ADDENDUM NO. 1

Date:	August 31, 2009
To:	Contractors
From:	Wayne Smith – Project Manager
Reference:	Price Armory Upgrade Utah National Guard – Price, Utah DFCM Project No. 08297480
Subject:	**Addendum No. 1**

Addendum #1
Price Armory – Structural repairs and upgrades
548 North 500 East
Price, Utah
DFCM Project # 08297480

Partial AD101

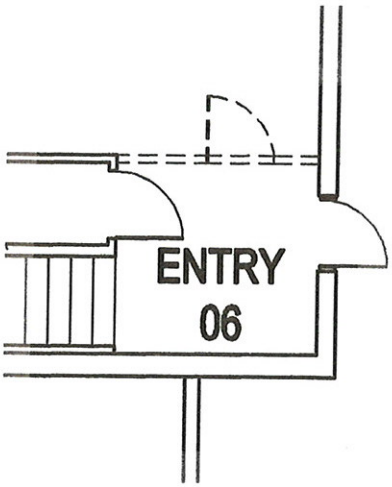
Revise basement demolition plan drawing to show demolishing the wall and door between Entry 06 and Garage 01 as shown on the attached partial plan AD101.

Correct north arrow – should point to left side of page.

Partial AE101

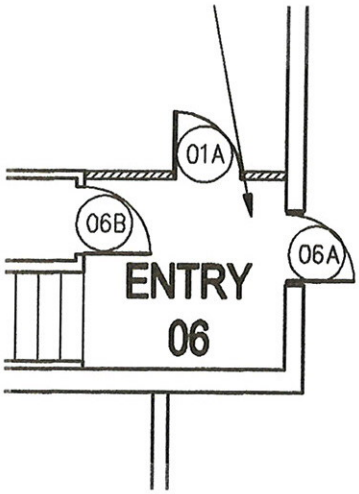
Revise basement floor plan drawing to show a new wall with new door between Entry 06 and Garage 01 as shown on the attached partial plan AE101.
